## **Addendum #01 for RFB #951800-01**

Project Name: DOM-IT Jessie Parker South Renovation

Date: April 21, 2026

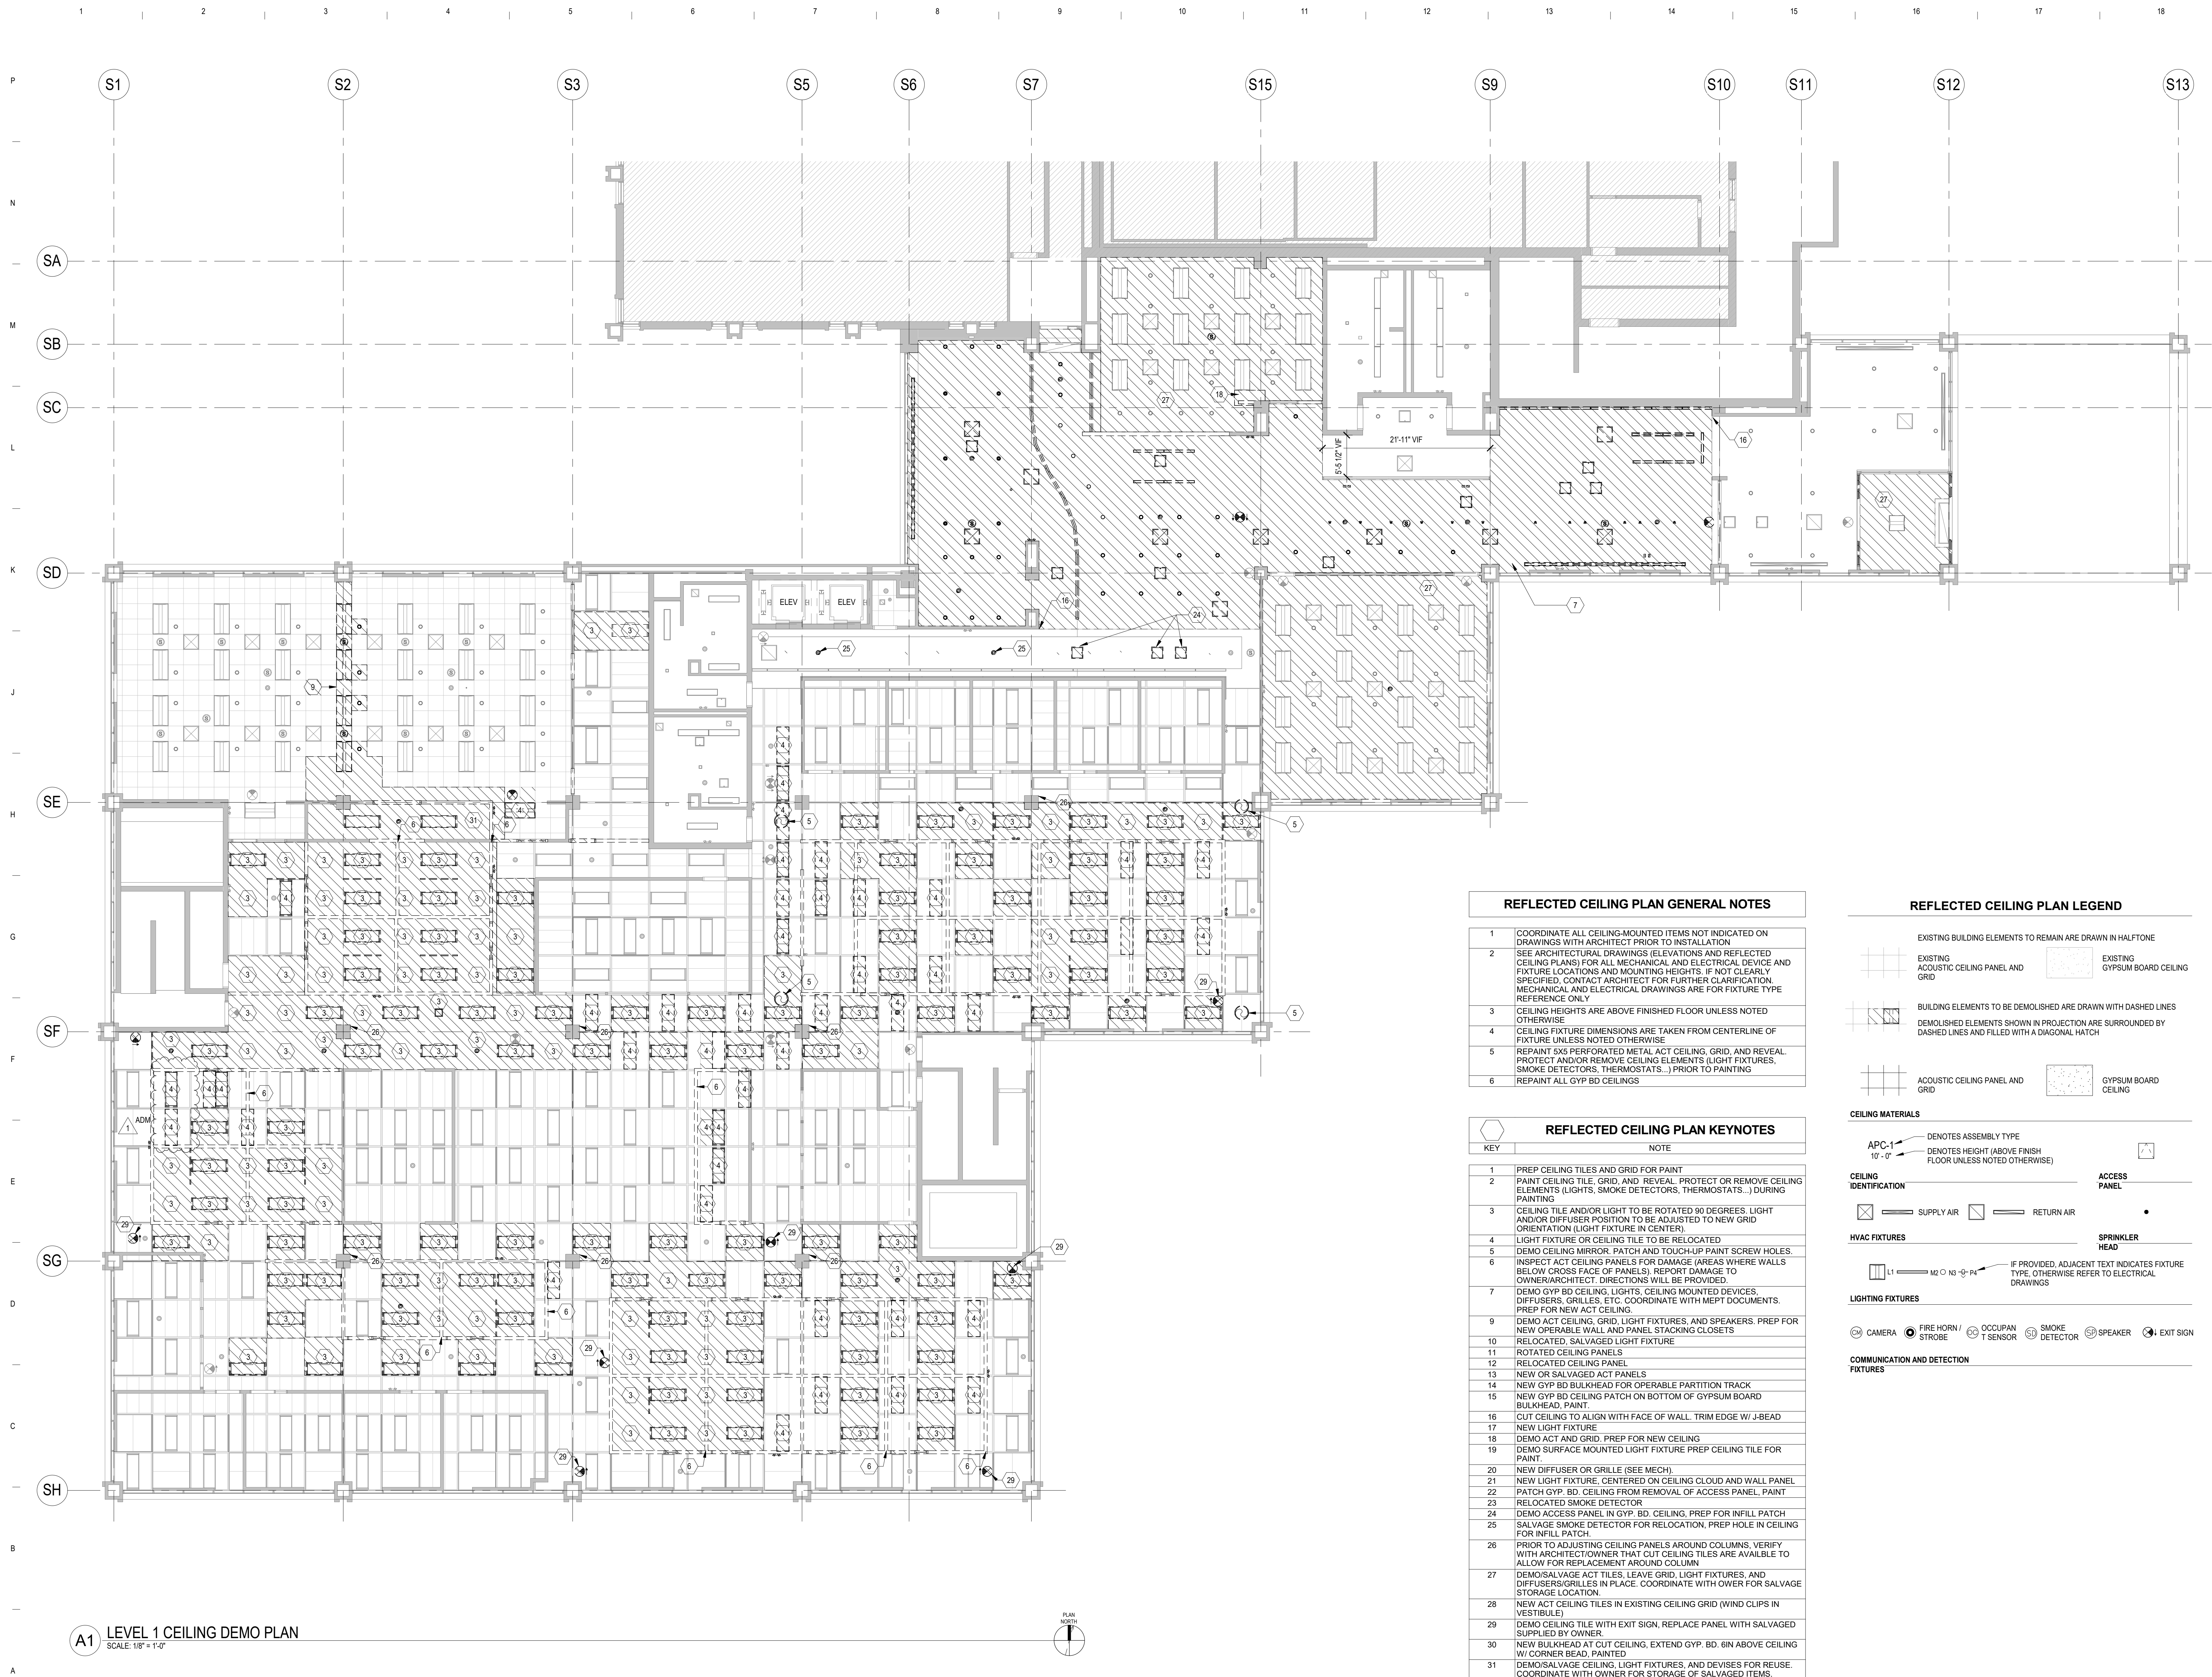
1. A0.90 – Reflected Ceiling Demo Plan – Lower Level
  - a. REPLACE original sheet with the revised sheet included in this addendum.
    - i. Removes elevation tag that was included in error.
2. A0.91 – Reflected Ceiling Demo Plan – Level 1

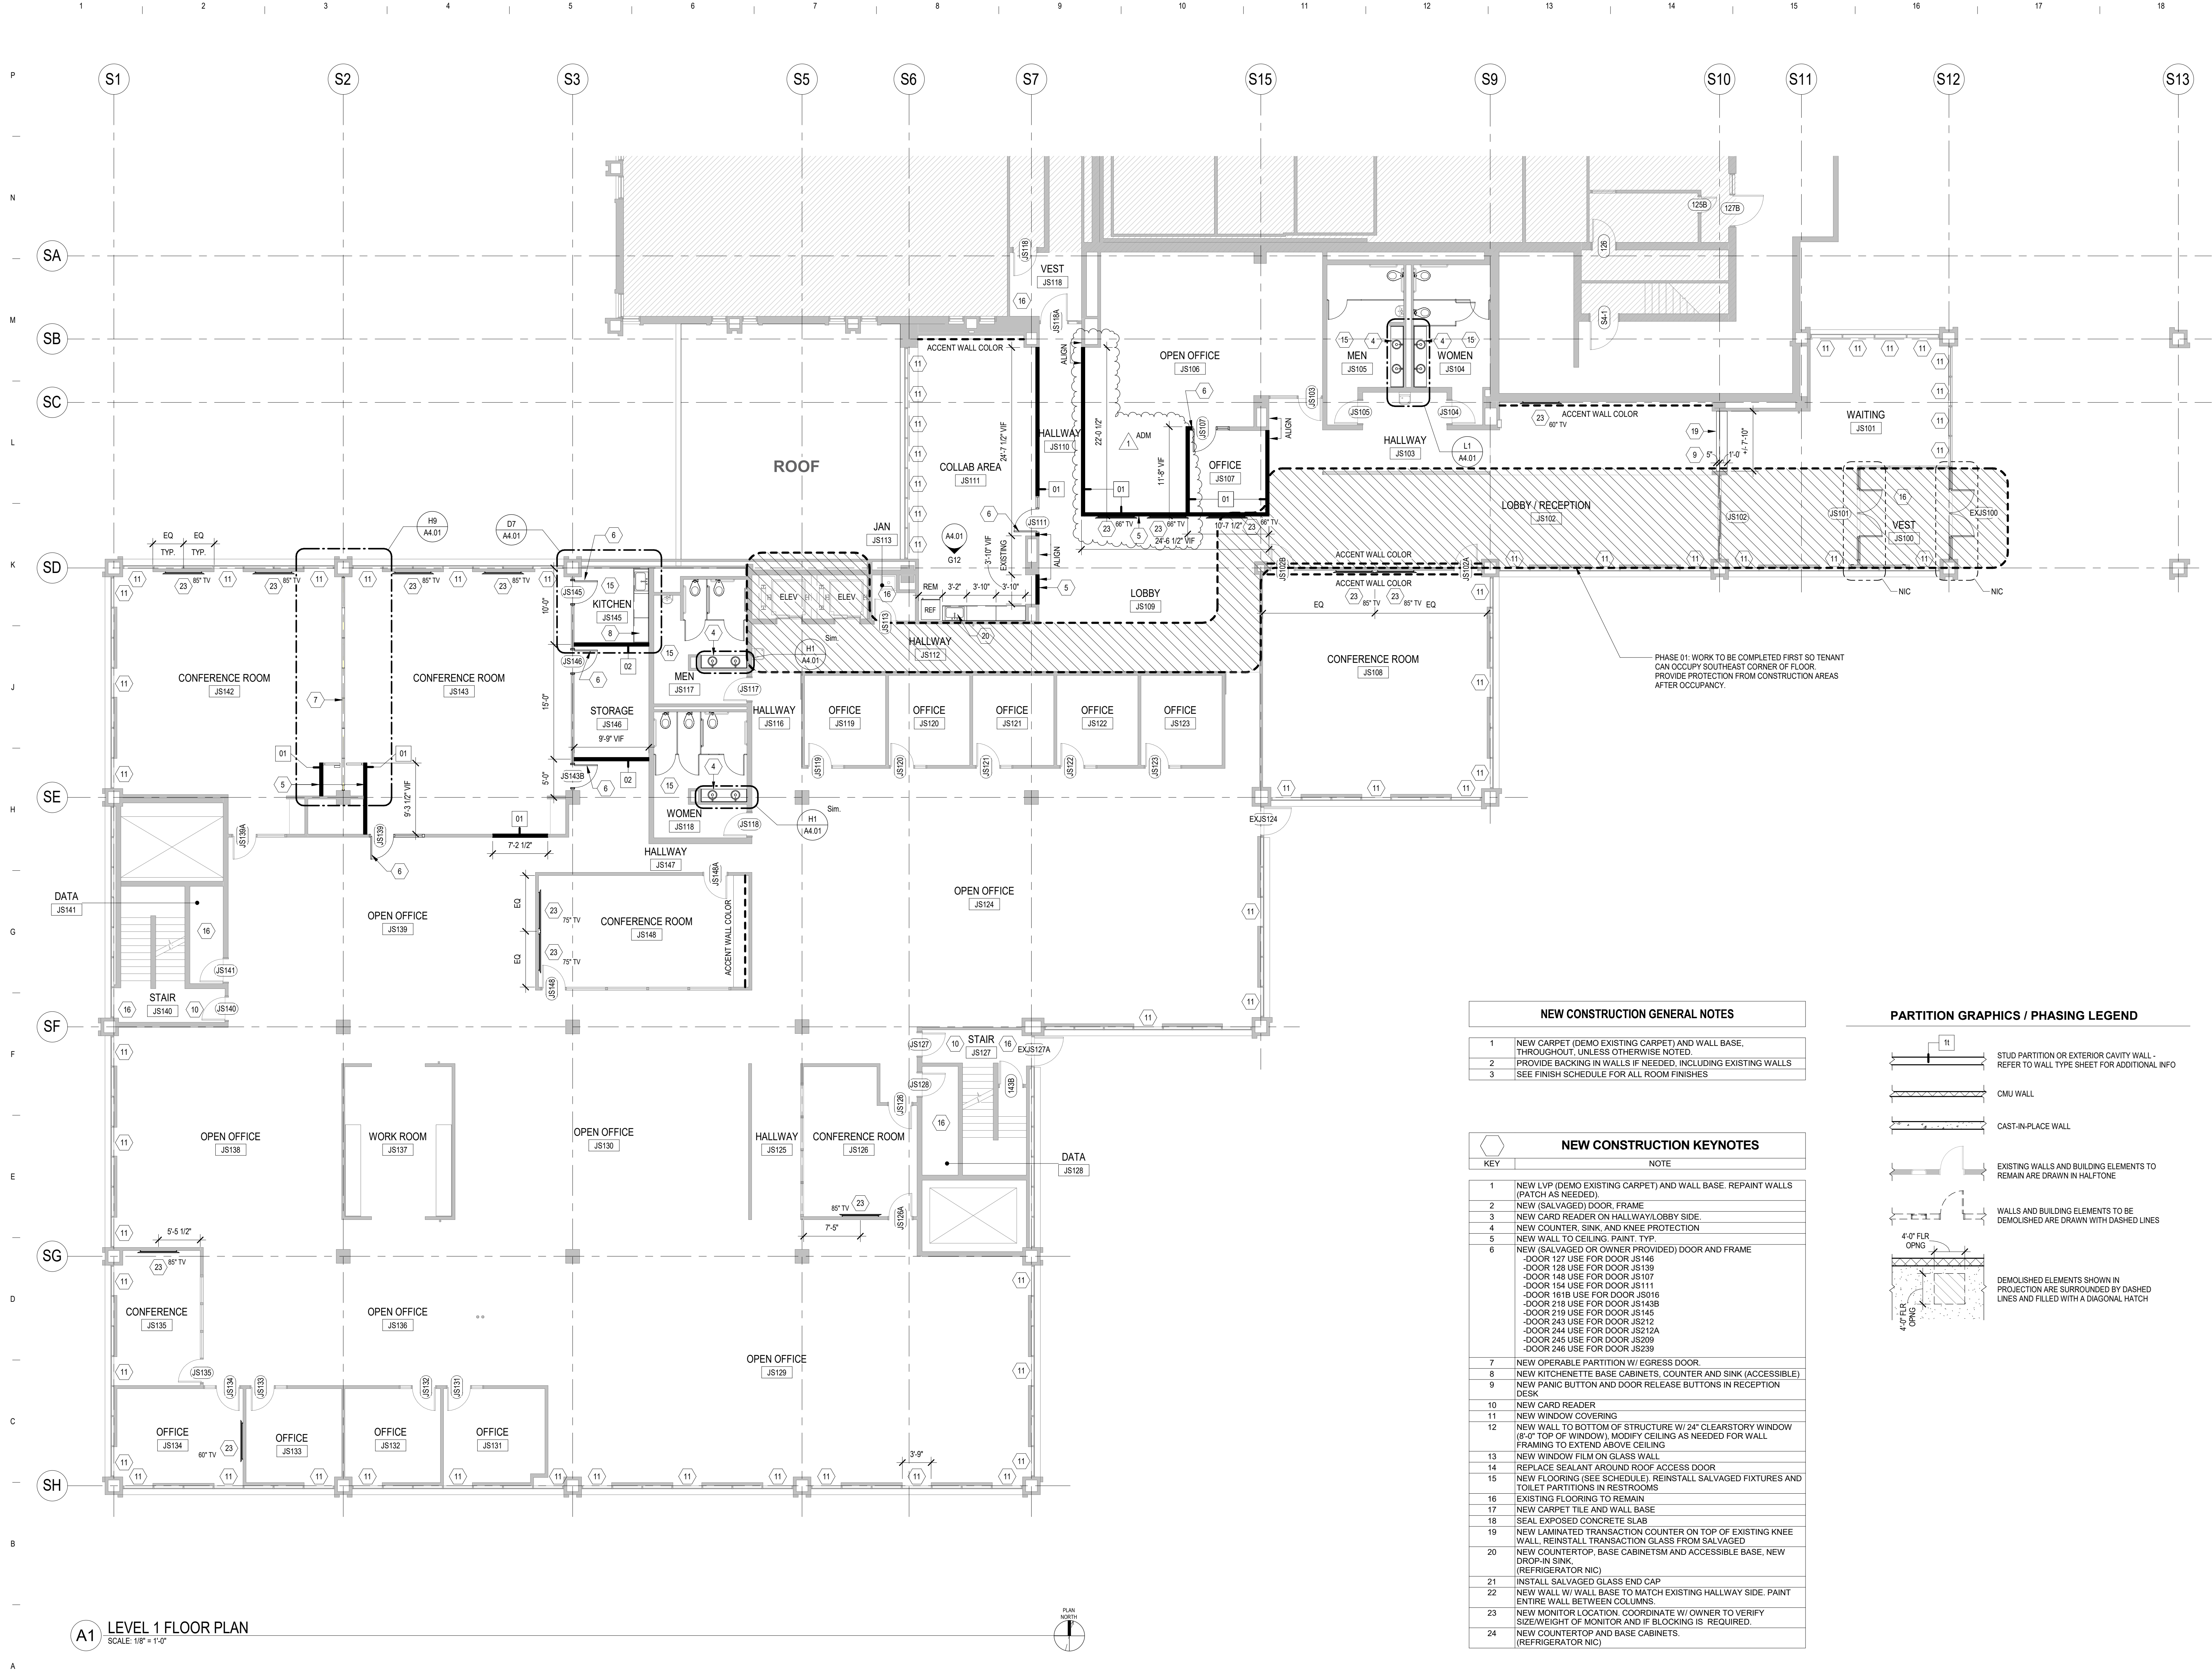
- a. REPLACE original sheet with the revised sheet included in this addendum.
    - i. Removes elevation tag that was covering demo notes.
3. A1.01 – Floor Plan – Level 1

# E101

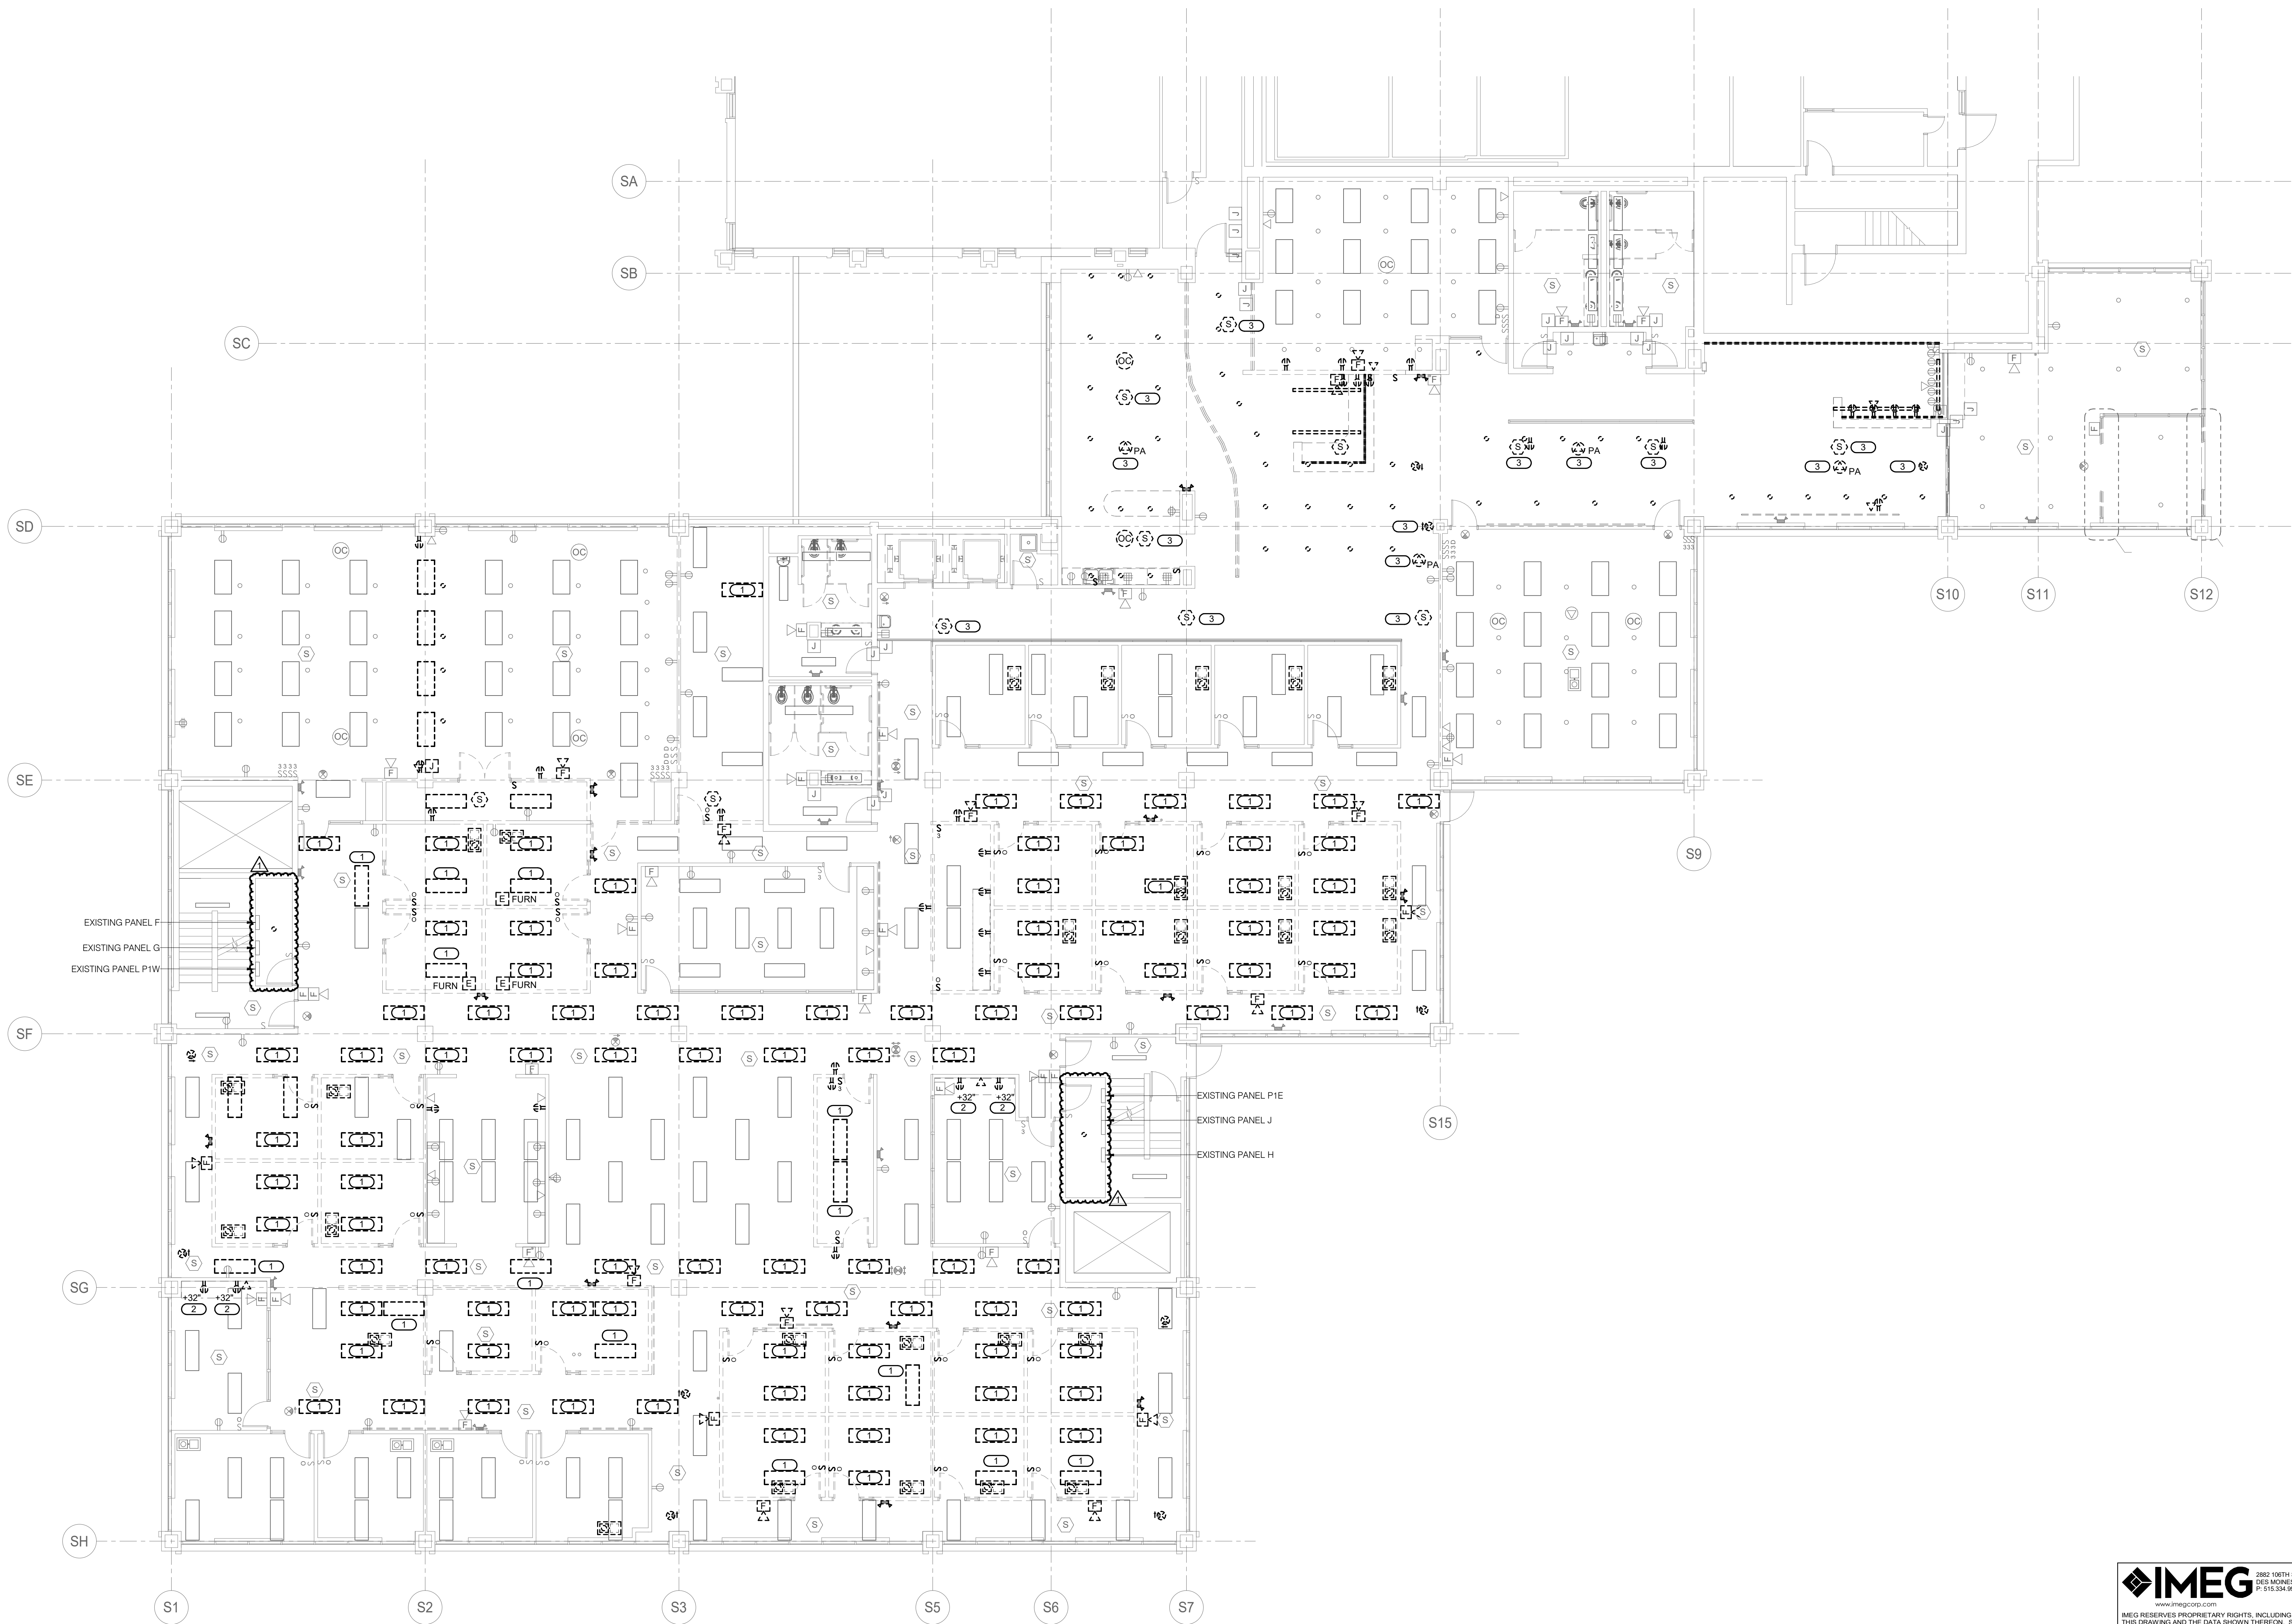
- i. Revises floor finishes and layouts.
5. E101 – Level 1 Demolition Plan - Electrical
  - a. REPLACE original sheet with the revised sheet included in this addendum.

- i. Adds demolition scope of lighting in existing Data Rooms.
6. E102 – Level 2 Demolition Plan - Electrical
  - a. REPLACE original sheet with the revised sheet included in this addendum.
